SAFER Bay Project

ECRB Meeting 10/23/2026

Geotechnical and Geology Issues

Historic Geology Considerations for EPA Reach

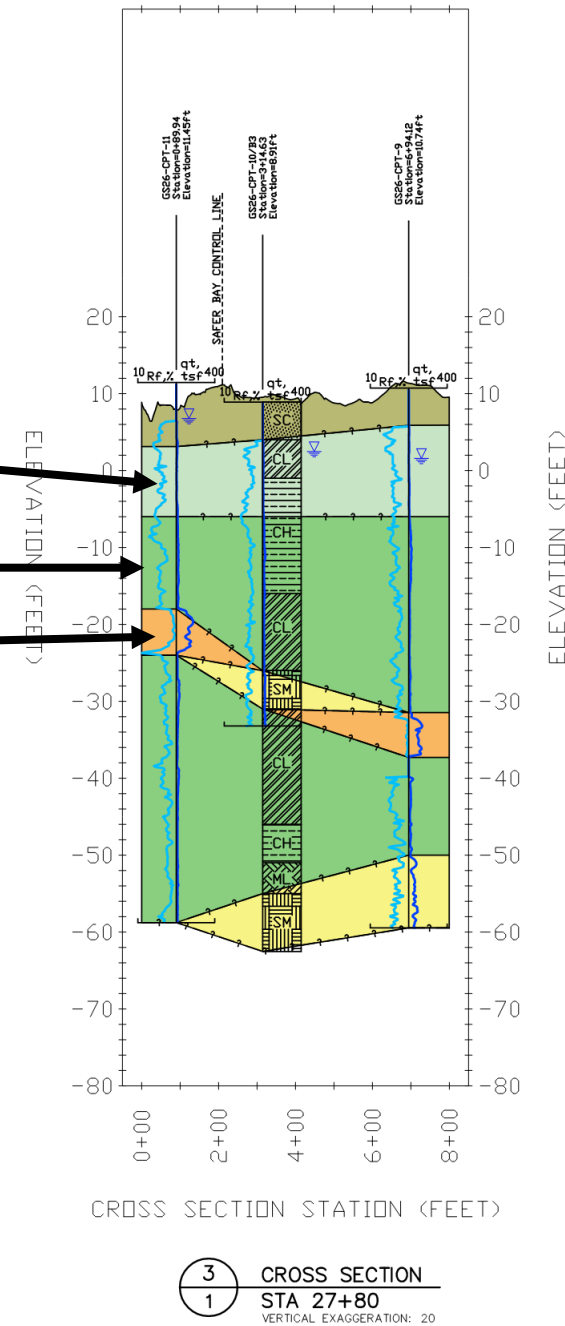
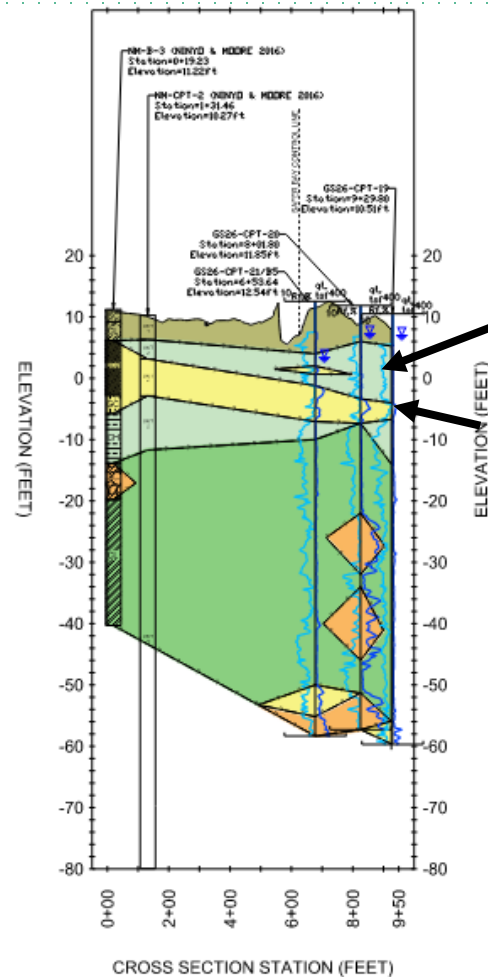
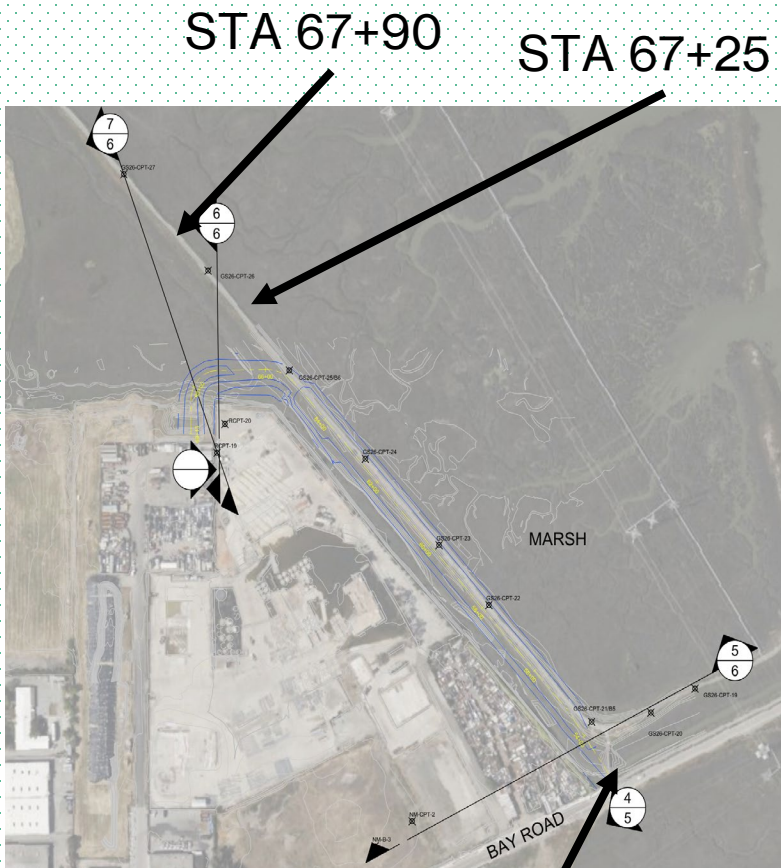
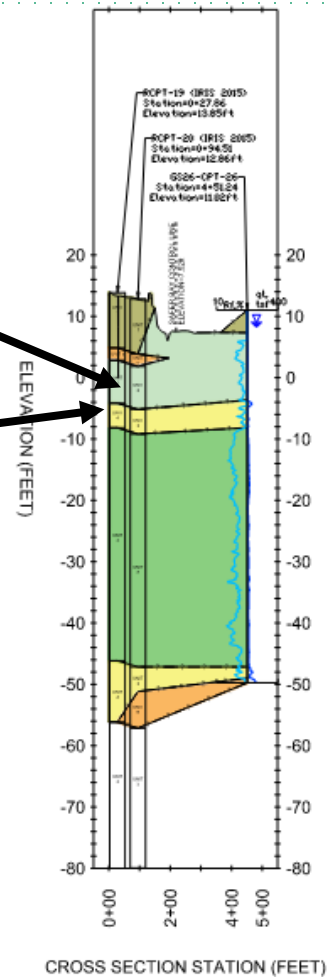
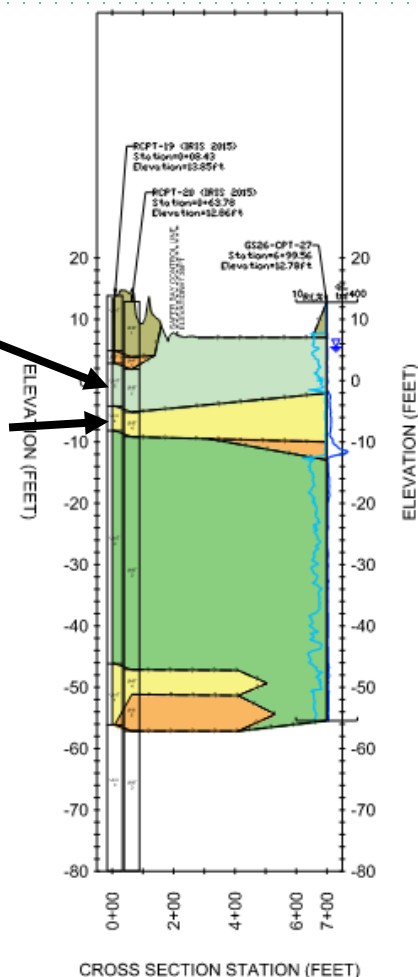
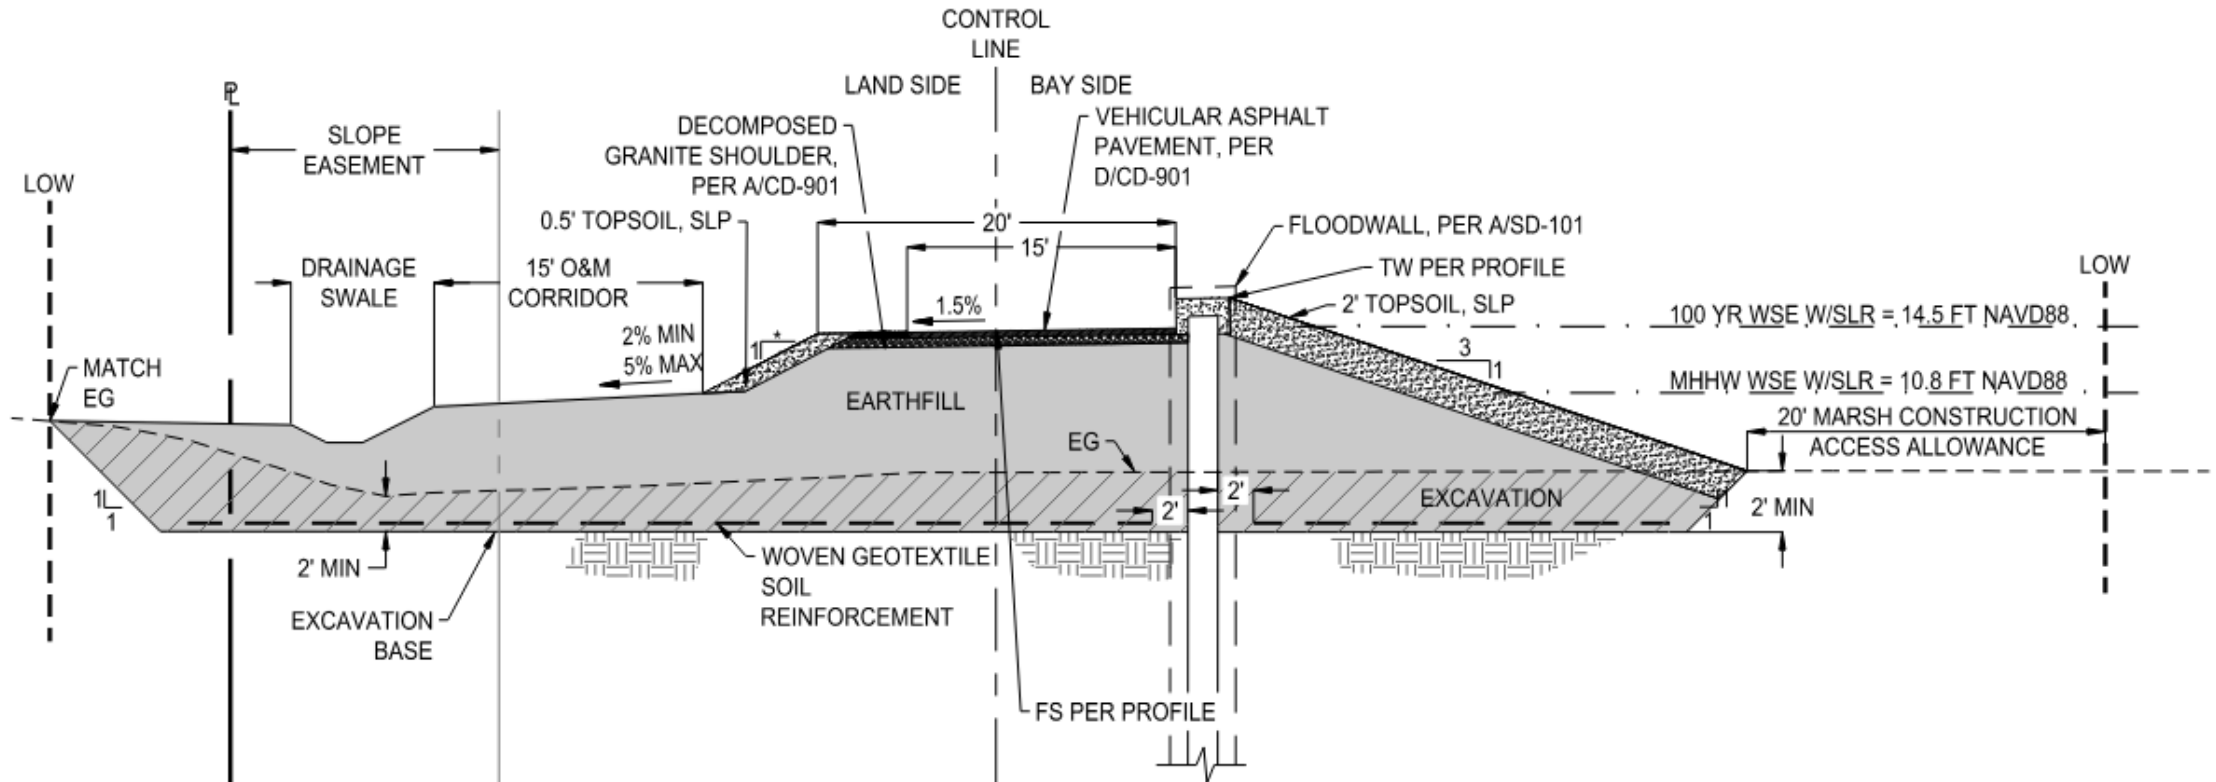
- ECRB Comment: the ECRB flagged the risk of underconsolidated soils overlying sand lenses in the East Palo Alto geological profile, as well as the potential for elevated pore pressures related to these sand lenses. The ECRB recommended that additional pore pressure measurements be taken orthogonal to the levee footprint to better characterize this condition.

- The design teams have gathered information on the dry and wet sides of the levees at accessible locations with the purpose of developing seepage models for gradient evaluation. The marsh on the wet side, and the developments on the dry side, restrict access to perform explorations. In the upcoming ECRB meeting, the design team will present the information we have gathered for the geologic conditions orthogonal to the levee including the design cross sections and the results of seepage analyses which evaluated exit gradients through the overlying young bay muds. It should be noted that for much of the levee alignment, the dry side includes fill to create drainage swales that will also counteract upward gradients. Also, the overlying young bay muds are generally thick when compared to the hydraulic levee height. Additional pore pressure measurements are not able to be collected at this time.

Soil Properties

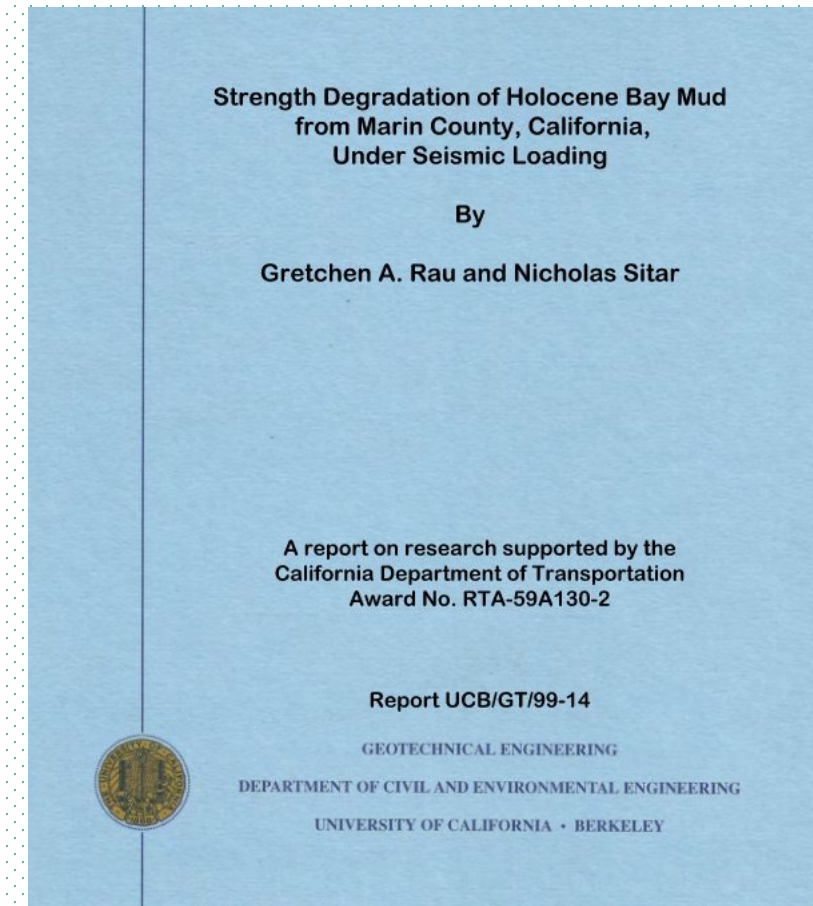
- ECRB Comment: In order to determine dynamic strength of soils at the project site, the ECRB pointed to simple shear test data in a UC Berkeley PhD dissertation as a useful reference for the project's ongoing seismic analysis.
- Confirmed, a 10% reduction in nominal strength for YBM unit is considered to account for cyclic degradation
- Reduction based on "Strength Degradation of Holocene Bay Mud from Marin County, California, Under Seismic Loading by G. A. Rau and Nicholas Sitar, Report UCB/GT/99-14"

The post-cyclic monotonic strengths are within $\pm 10\%$ of the monotonic strengths of specimens that had not undergone cyclic loading. There were no clear effects of varying

Soil Properties - Density

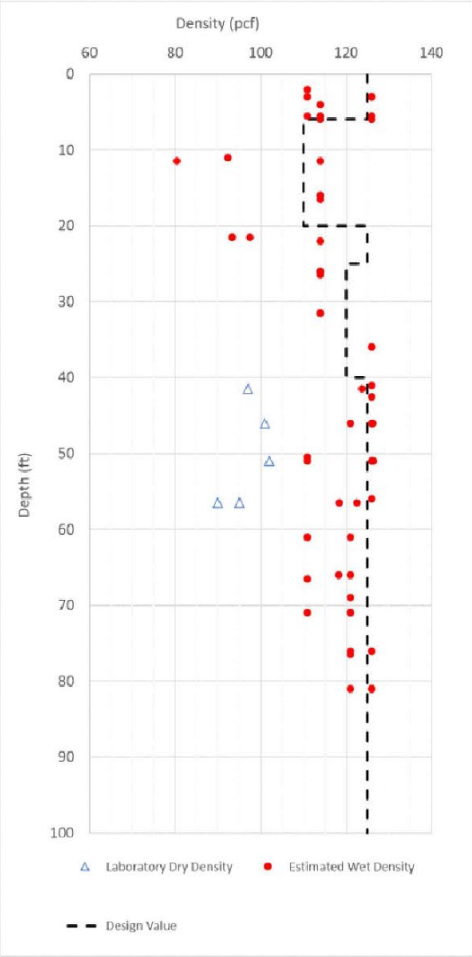
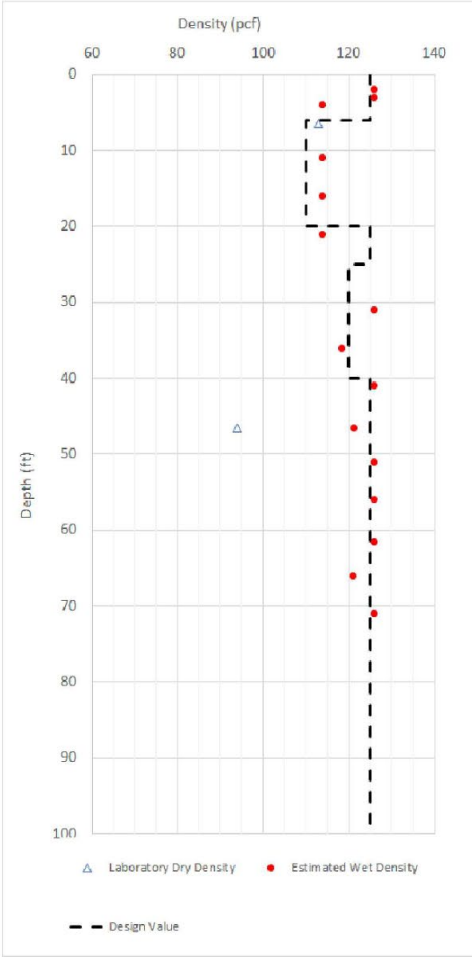
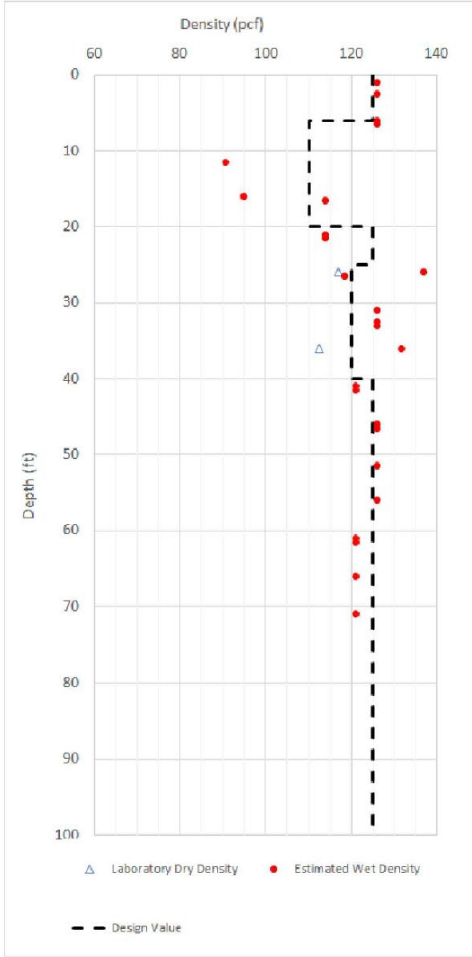
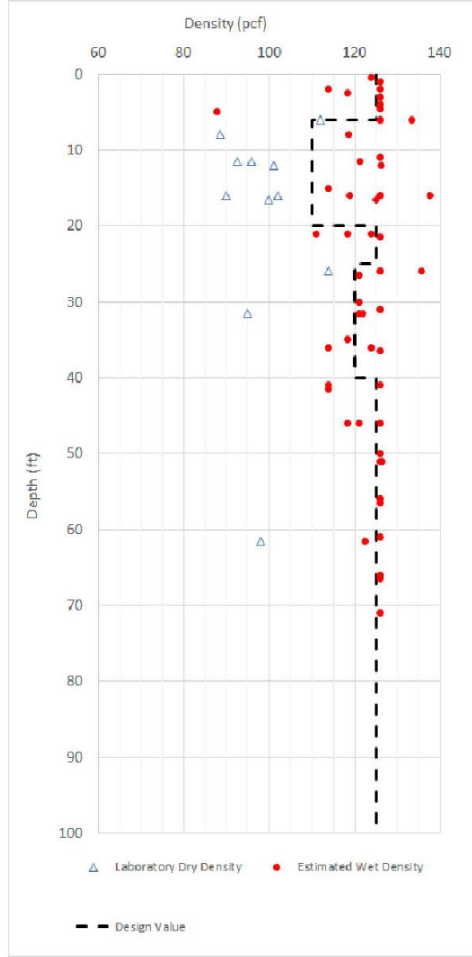
- ECRB Comment: The ECRB requested that information related to how soil properties were derived from historic exploration data be provided to the ECRB. BCDC staff recommends that this documentation be provided in the form of an updated Basis of Design report.
- The next series of slides shows plots of material parameters based subsurface data in the vicinity of the cross-section being analyzed and includes:
 - Density
 - Undrained Shear Strength
 - Drained Friction Angle
 - Hydraulic Conductivity

- Sta 321+00

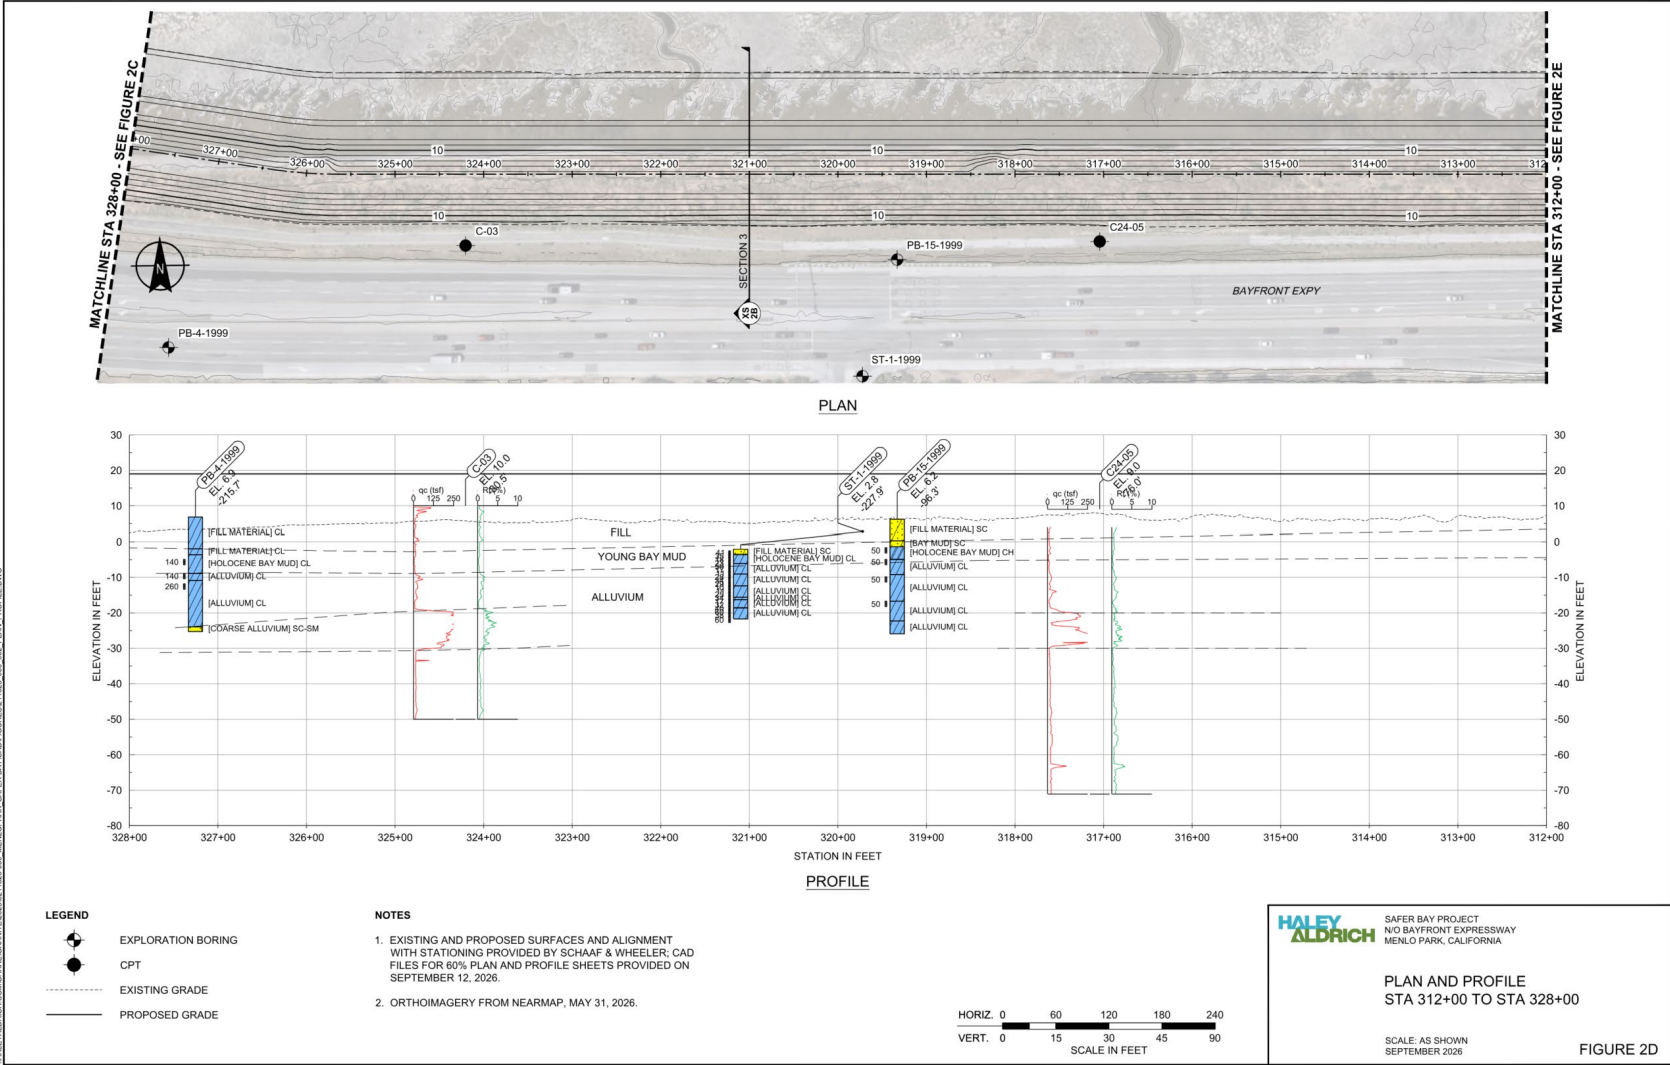
- ECRB Comment: The ECRB requested that a longitudinal geological profile for the Menlo Park project reaches under review be provided to the ECRB. BCDC staff recommends that this documentation be provided in the form of an updated Basis of Design report.
- The next series of slides are longitudinal profiles at our analysis cross sections. Profiles for the full Menlo Park alignment are in our draft BOD. As noted previously, four typical sections at Project Stations 217+00, 245+00, 280+00, and 321+00, and representing each of the three project reaches, were selected for analysis based on height of new fill, thickness of Bay Mud, and the presence of significant sand layers.
